**GULF STATES UTILITIES COMPANY**

July 31, 1986  
RBG- 24,131  
File No. G9.5

River Bend Station - Unit 1  
Docket No. 50-458

Gulf States Utilities (GSU) January 23, 1985 letter (RBG-19,972) transmitted GSU's final updated response to containment issues. Your review and remaining open items are documented in Supplement No. 2 - Appendix K of the River Bend Station Safety Evaluation Report (NUREG-0989), a June 25, 1985 letter from H. R. Denton to W.J. Cahill requesting additional information, and NPF-47 License Condition 2.C.(5). The enclosure to this letter is GSU's response to these open Mark III related issues.

Figure 2-1 Effect of GMS Encroachment on Containment Wall Boundary Load During Pool Swell

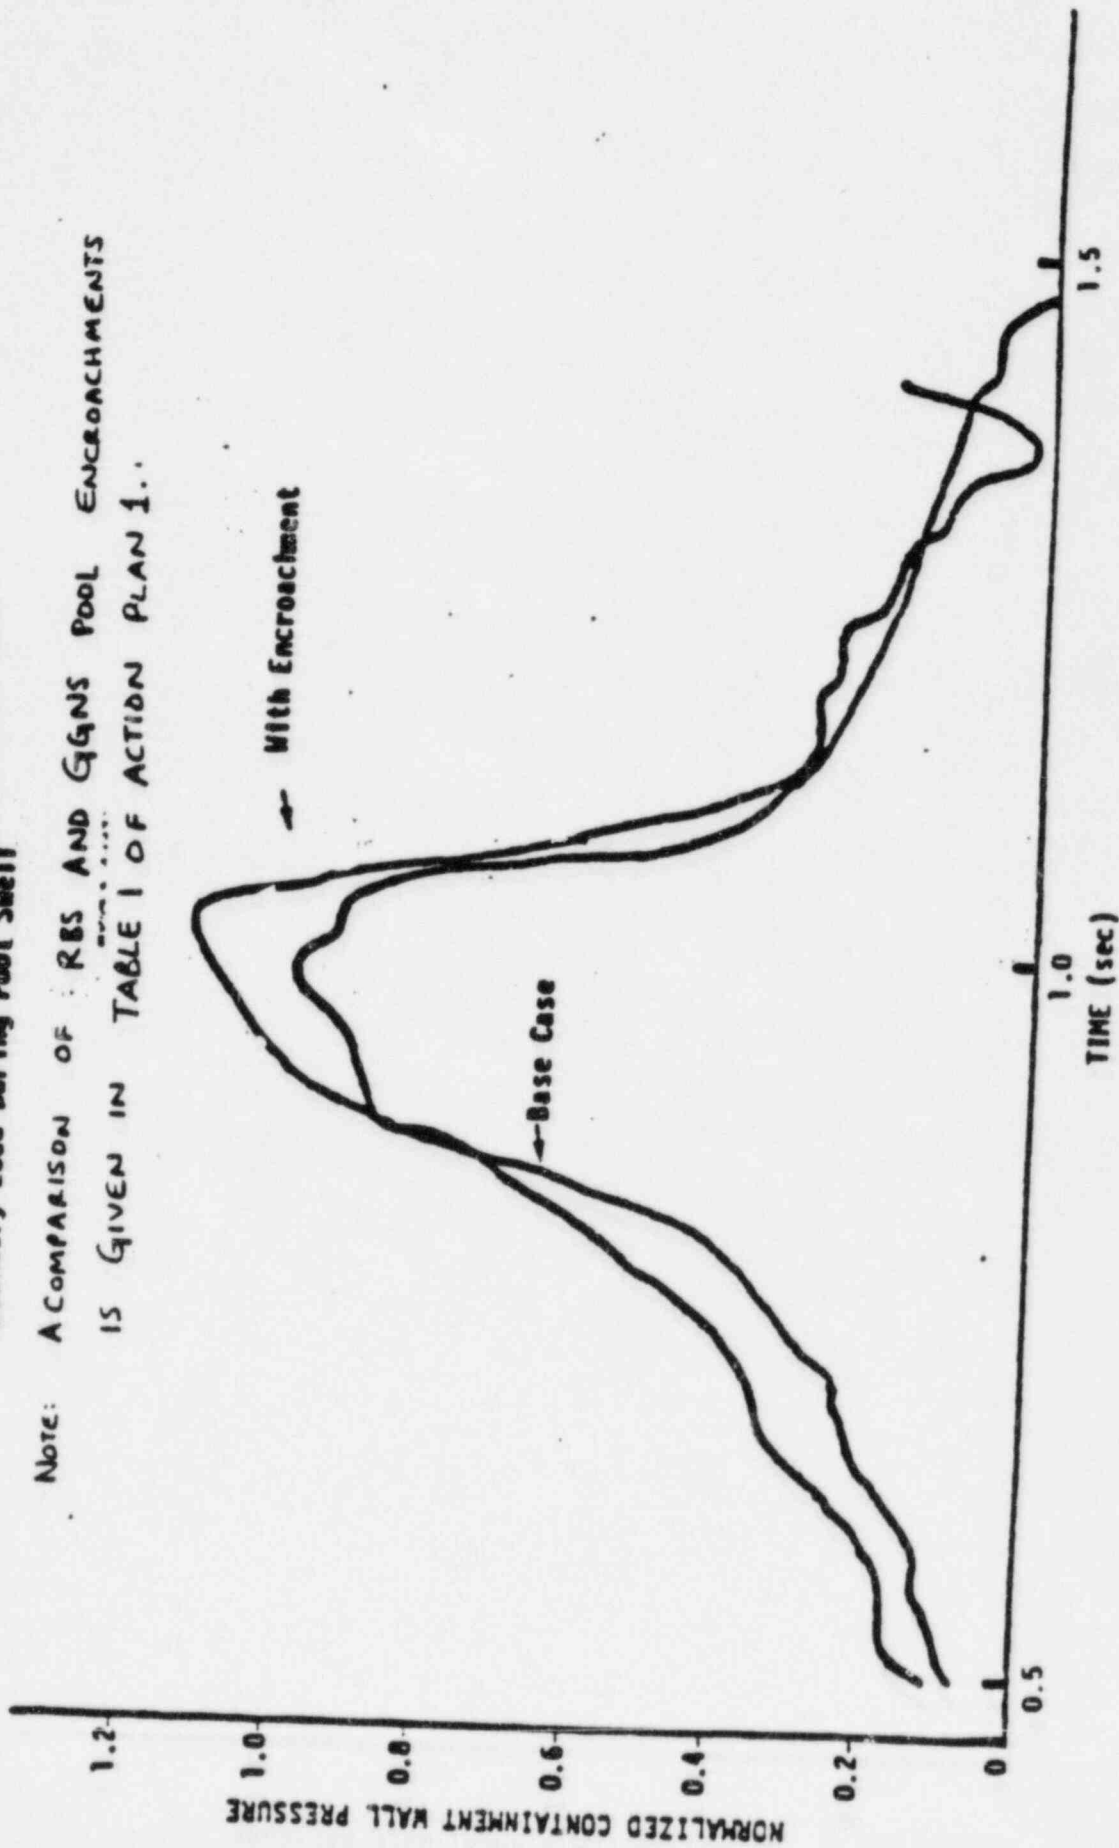
Pressure on the containment wall is a direct output of the SOLAVO1 code. In the full scale PSTF geometry, the containment wall is located 19 ft from the vent exit as opposed to 20.5 ft for RBS. Since the River Bend pool is wider, the 10 psid design load is extremely conservative. The base case for evaluating the potential increase in pool boundary loads on the containment wall was established as the GGNS geometry with a 19-ft pool width. The pressure loading curve on the containment wall was calculated and then normalized so that the peak pressure corresponded to the design pressure of 10 psid. The pressure loading curve was then recalculated for the GGNS encroached case, and again normalized to the design pressure. A comparison of the base case and the design base case is presented in Figure 2-1.

The encroachment causes the wall pressure to increase by approximately 15 percent. This is, of course, only a local loading increase in the vicinity of the encroachment. This increase poses no concern from a design standpoint because the loading is of sufficient duration (0.5 sec) to be considered a static load. The 15 percent increase over the 10 psid design value is easily bounded by the 15 psid containment design pressure. Thus, encroachments do not adversely affect the boundary design loads.

Figure 4 - ARS Comparison on Drywell Wall

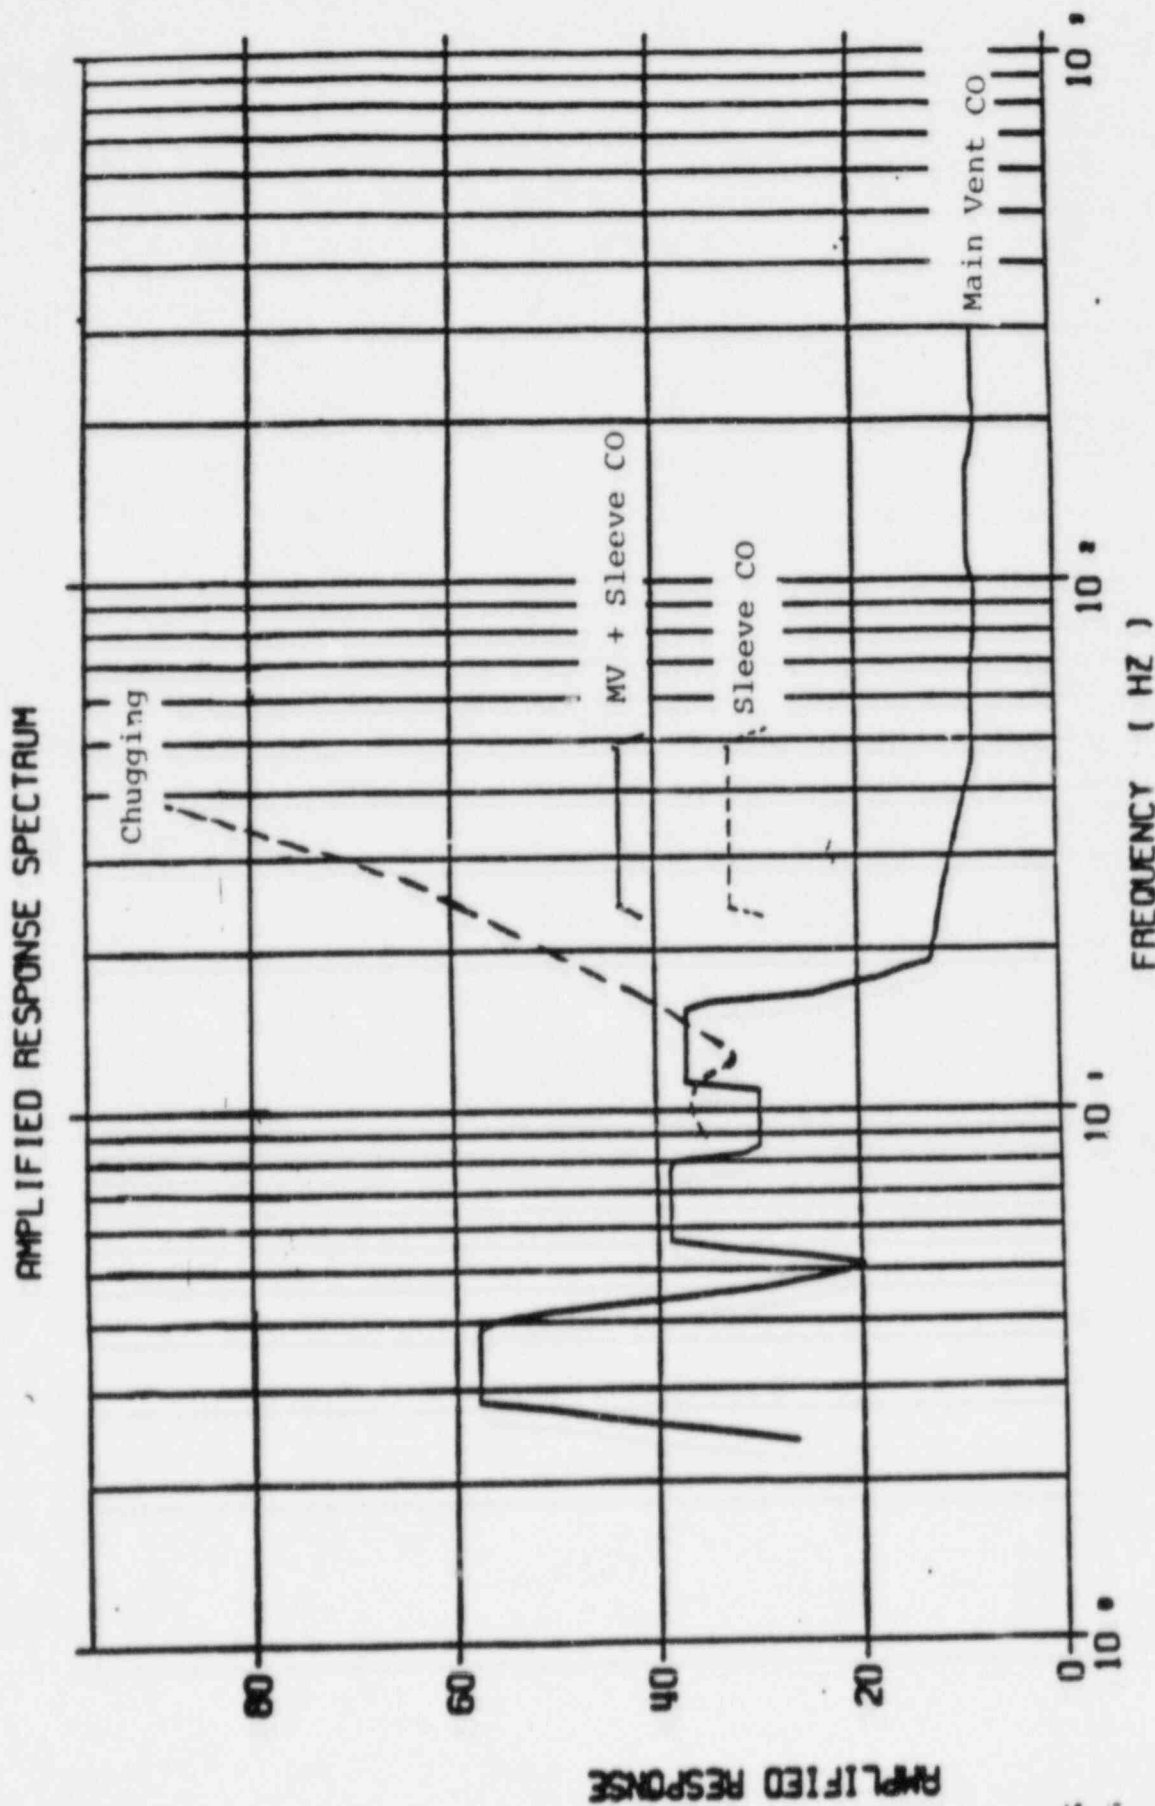
The amplified response spectra (ARS) values for estimated CO loads for the SRVDL sleeve and the main vent<sup>1</sup> are compared to ARS values for the pool swell and chugging wall loads in Figures A and B. The comparisons are based on the lowest frequency component of the SRVDL sleeve CO load. The CO loads for the two higher frequency components are less significant relative to the pool swell and chugging loads so they are not included in the comparison. This shows that the addition of the estimated SRVDL sleeve CO load to the main vent CO load results in a total CO load which is less than the chugging load on the drywell wall (Figure A) and the pool swell load on the containment wall (Figure B).

FIGURE 5-1

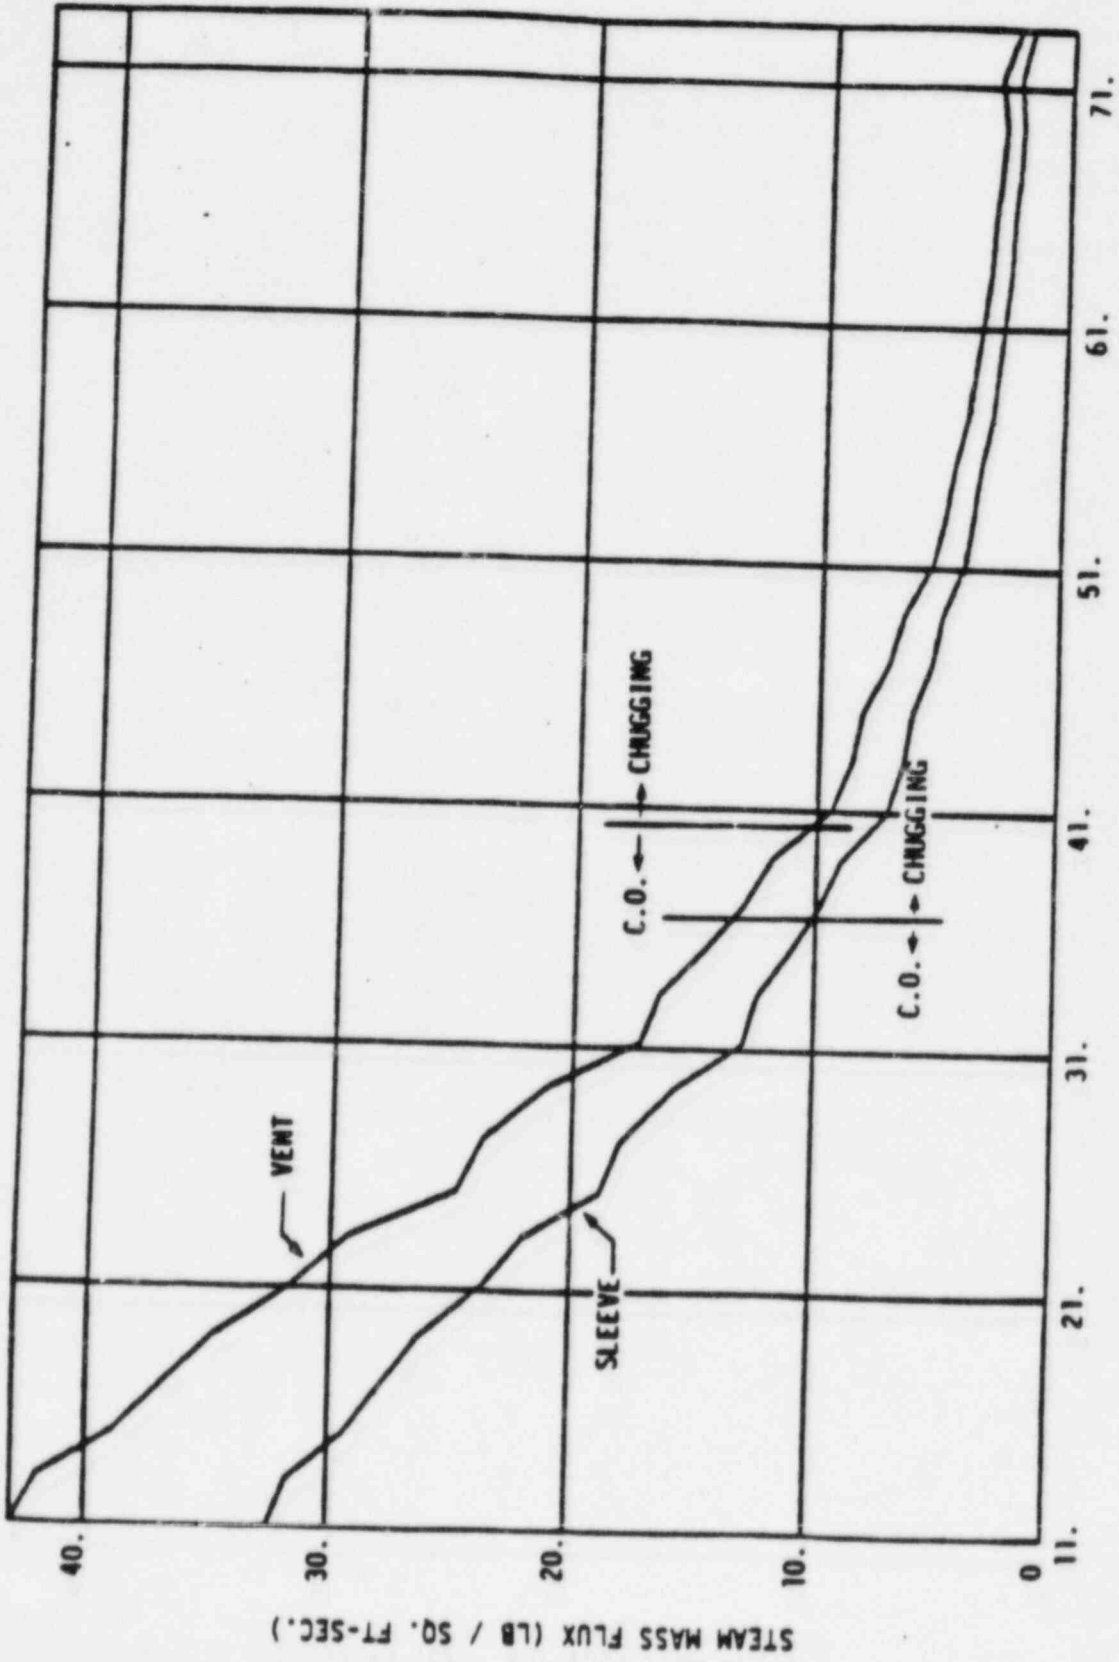
Since this ration is relatively close to unity, CO will occur in the sleeve during nearly the same time period of a LOCA as it occurs in the vent. To illustrate this, Figure 5-1 shows the vent and sleeve steam mass flux time-history calculated with M3CPT04 (Reference 7) for a Grand Gulf DBA. Assuming that transition from CO to chugging occurs near 10 lb/sq ft/sec, Figure 5-1 shows that generally the vent and sleeve will experience CO simultaneously.

FIGURE 5-2

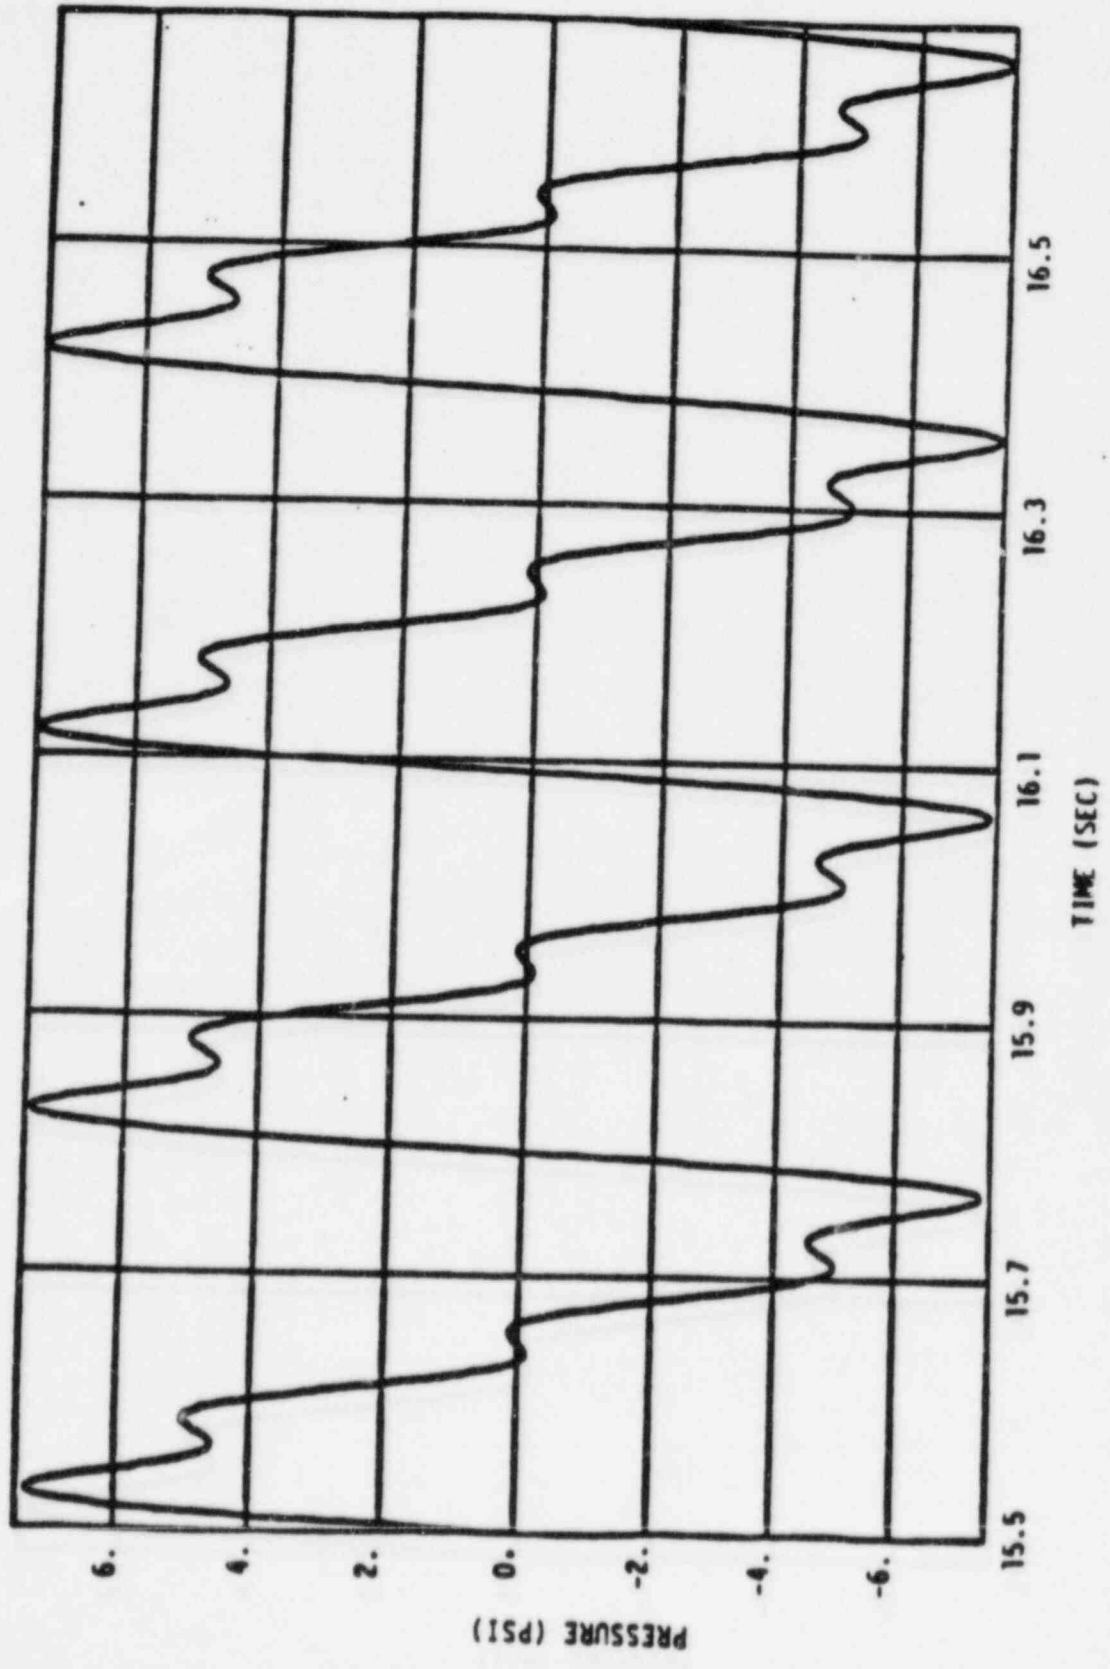
A portion of the resulting pressure time-history on the drywell wall for Grand Gulf is shown in Figure 5-2

FIGURE 5-3

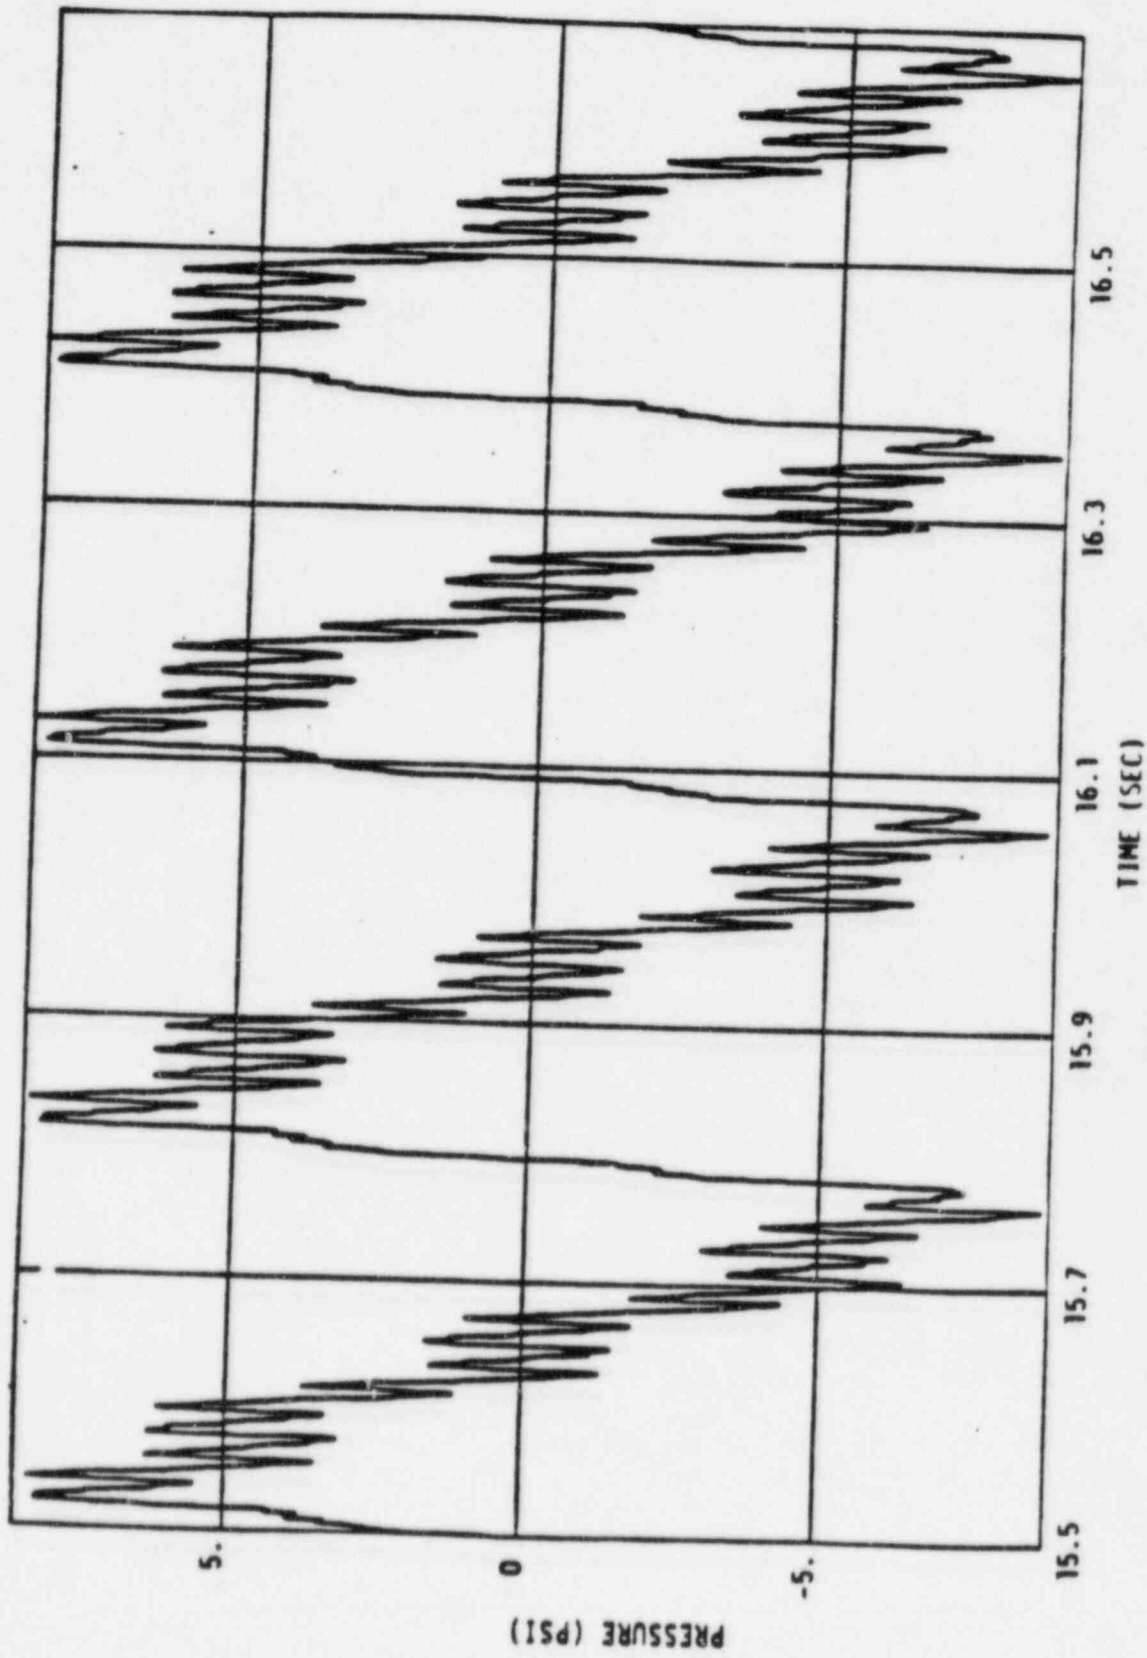
(vent CO only) and Figure 5.3 (simultaneous vent and sleeve CO).

Based on analysis for the loading provided in Figure 5-3, the resulting increases in structural forces and moments are not significant and are enveloped by other LOCA cases.

FIGURE 5-7

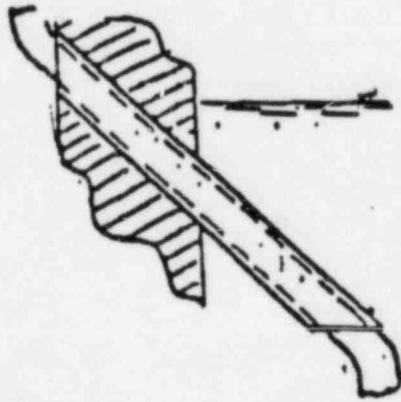
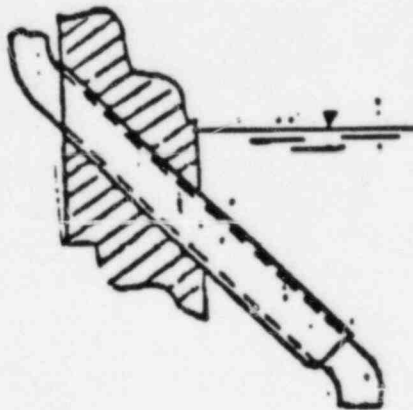
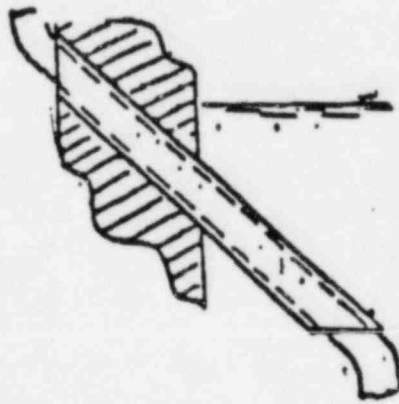
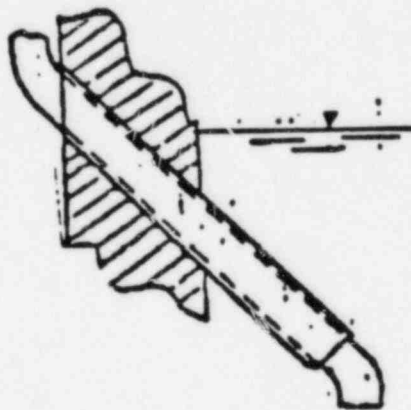
The SRVDL sleeve CO lateral loads for the Mark III sleeve geometry are not considered for the RBS design. The Grand Gulf SRVDL sleeve configuration has an unbalanced loaded area at the discharge end of the sleeve, which may introduce a dynamic lateral loading. The River Bend sleeve geometry does not have the unbalanced area. Therefore, there is no CO lateral load. See Figure 5-7 for comparison of sleeve geometries (Reference 13).
